# ASSESSOR'S RECORD MAP

209-05

## SECTION 04, TOWNSHIP 15 SOUTH, RANGE 11 EAST

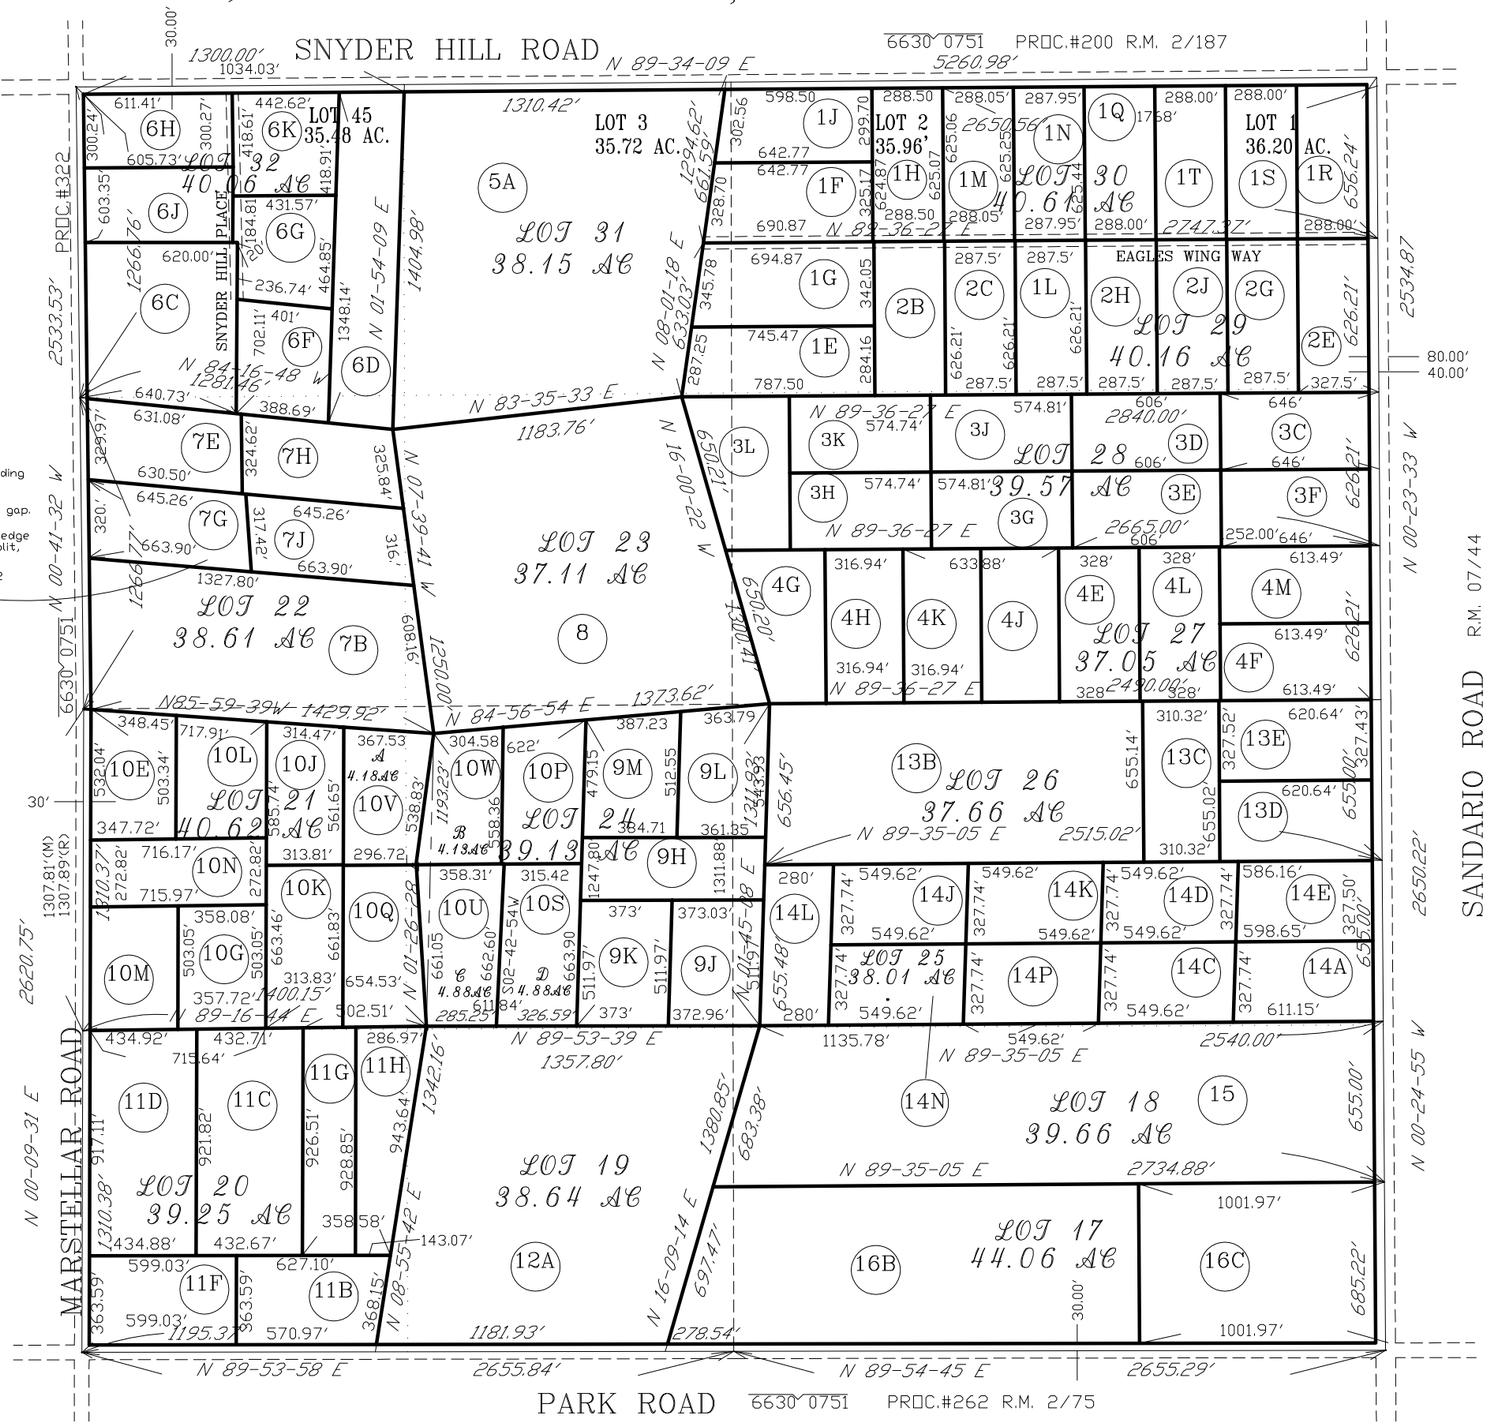
Review of Documents referenced in this note reveals long-standing confusion regarding W line of lot 22. It seems clear enough that 11746/8288 & 11899/6166 were expected to bisect the 1327.8' stretch of Duke property East of road, leaving no gap.

Recommend parcel '7G' shifts Easterly so dims reach the east edge of R.O.W. instead of lot edge, allowing common bndry with new split, (PCL '7J & 7H') DKT-11899/6166, matching dims to more likely physical disposition. RK 12/17/02
